Comment Report

21-7442

1. MEYER 2/18/1992 BUFFALO RIVER ESTATES

To: Whom it May Concern
From: Joseph Larsen
Date: September 25, 2007
RE: Processing Field Reports for Permit Numbers 21-7442 and 21-7583

Buffalo River Estates

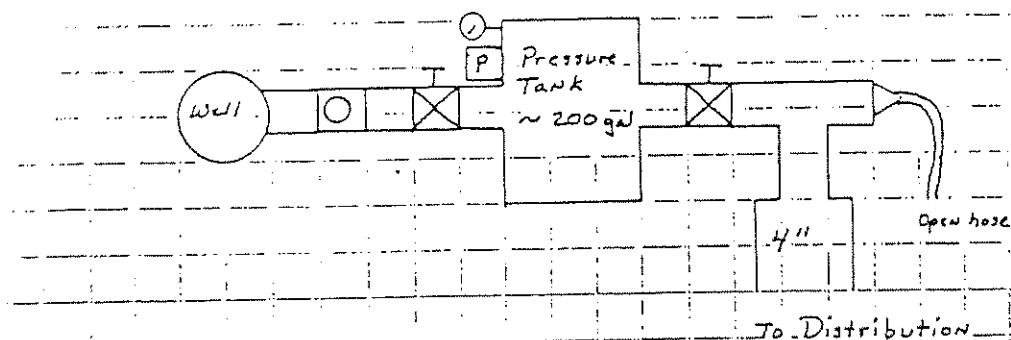
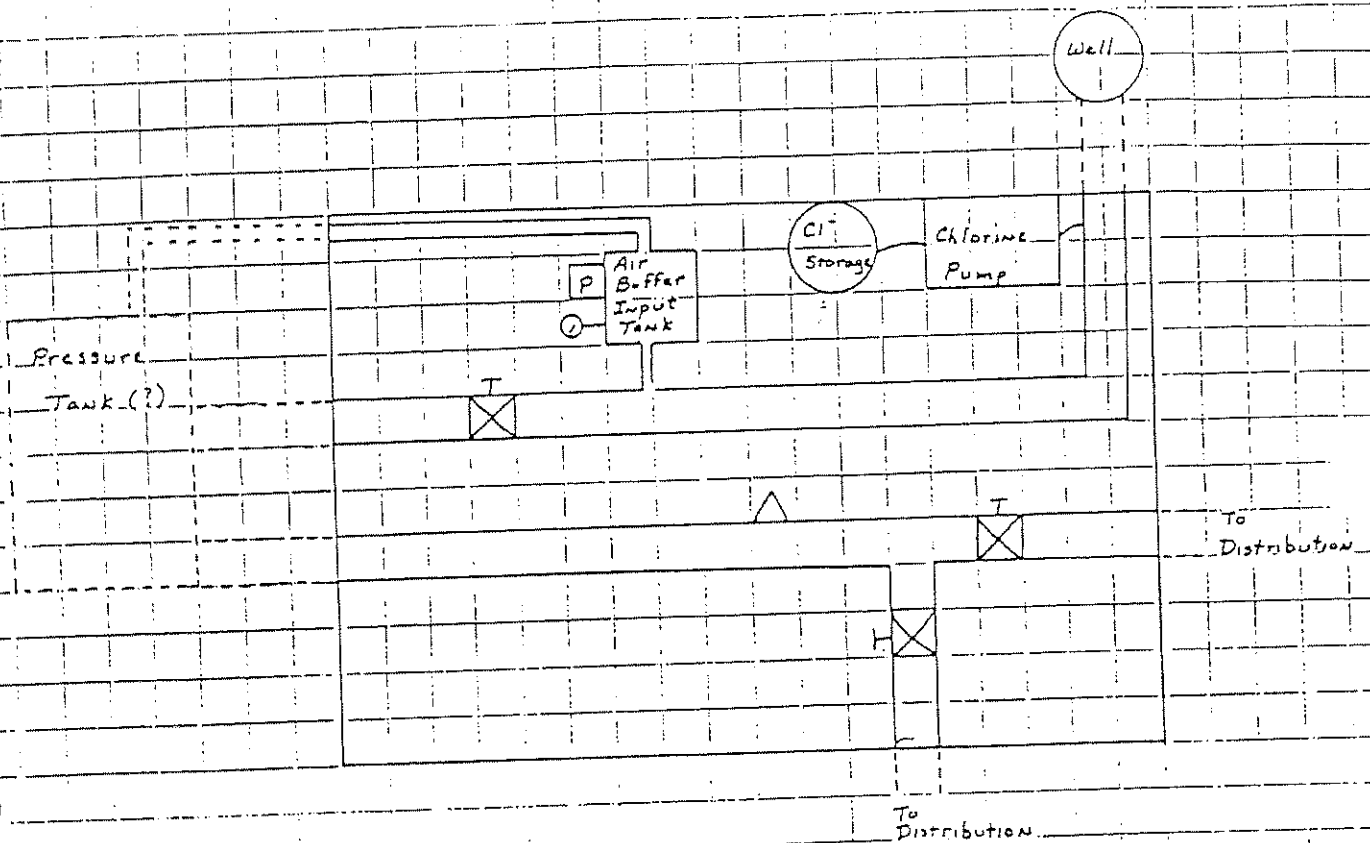
Comment: This system contains three wells. Currently wells #1 and #2 are tied together and deliver water to Subdivisions #1 and #2. The water mains in Subdivisions #1 and #2 are 2 inch and are buried along the edges of the roads. All lots are stubbed in. Conditions of Permit state that this Permit be limited to use by 70 homes. Subdivision 3 is not connected to the other two subdivisions. It receives its water from Well #3. The mainlines are 4 inch and the trunklines are 3 inch. They also run along the edges of the roads.
